# **Response Letter**

The manuscript has been revised and improved again according to the comments raised by two reviewers and the Editor and highlighted in blue in this version of the manuscript. A list of responses is itemized as follows.

Figure R1. Monthly average ground temperatures at depths of 0-20 m recorded in the JS-B-I borehole at the JS site in 2019 (a) and 2020 (b).

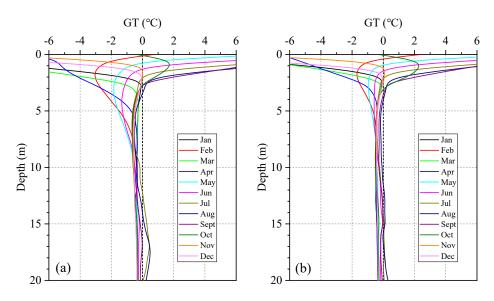
L192 – Figure 3 – Which JB site is being shown, JB-B-1 or JB-B-11? In my comments on the earlier draft, I had asked whether the variation in the deeper temperatures might be due to an issue with a sensor. For JB there appear to be spikes (sharp increases) in the temperature record. We see these periodically in our data and it is likely due to some electrical glitch with sensor and logger. This fluctuation of up to 0.5°C at depths of 10-20 m does not seem to show up in the profiles shown in Figure 5. For JS, the "noise" for the deeper sensors seems to be greater than that for the shallower sensors. The record also doesn't appear to be continuous and perhaps the authors have removed data points they determined were erroneous. If the temperatures measured by the deeper sensors are correct then it would seem that the temperature does not stay below 0°C throughout the year at any depth so perhaps no permafrost present?

Up to 38% of the temperature data in borehole JB-B-II were missing in 2019 (between late March and early August) due to the detachment of the thermistor cable from the CR3000 data logger. Therefore, the GTs measured in borehole JB-B-I are graphed in Fig.3, considering continuity and long time series of data. The sharp increase in the deeper temperatures might be due to some electrical glitch with the sensor and logger, as you stated. For assessment of the inter-annual trend of permafrost off the ROW, a decade record of GTs in borehole JB-B-II was used. Fig.5 shows the monthly average GTs in 2018 in this borehole. Therefore, abnormal fluctuation in temperatures at depths of 10-20 m does not show up in the temperature profiles.

At the JS site, the off-ROW borehole JS-B-I and two on-ROW boreholes of JS-B-1 and JS-B-2 are all connected to a data logger. For these two boreholes on-ROW, high-quality temperature data series were collected. Thus, the sharp increase in the deeper temperatures for the JS-B-I borehole in the summers of 2019 and 2020 was not caused by the data logger. The phenomenon of temperature increase at depths of 10-20 m was observed for two consecutive years (Fig.R1),

which would seem to indicate that the failure of the thermistors is impossible. As Fig. R2 show, Large surface runoff occurs in low-lying areas at this site in mid-June, resulting in occasional floods and waterlogging. Meanwhile, the strata of this site (obtained from the JS-B-I borehole) are composed of peaty soil (0-0.8 m), grey silty clay (0.8-2.0 m), yellowish-brown gravel (2.0-5.5 m), and strong weathered granite (5.5-20.0 m). The presence of the rock layers with high permeability provides a channel for the movement of supra- and/or intra-permafrost groundwater. For the above-mentioned reasons, we conclude the positive temperatures that occurred from late June to September are probably due to the thermal disturbance of supra- and/or intra-permafrost groundwater.

Figure 10. Temporal history of soil volumetric liquid water content at depths of 0.5, 1.5, and 2.5 m at the JB site along the China-Russia Crude Oil Pipeline (CRCOP) I in the northern part of Northeast China during 2015-2021.

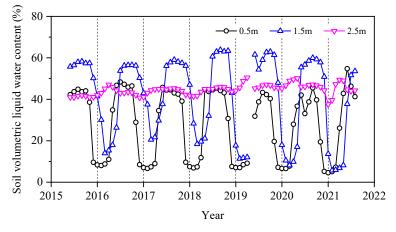
L273-274 - VWC could be given as a %

It was changed and Figure 10 has been revised.
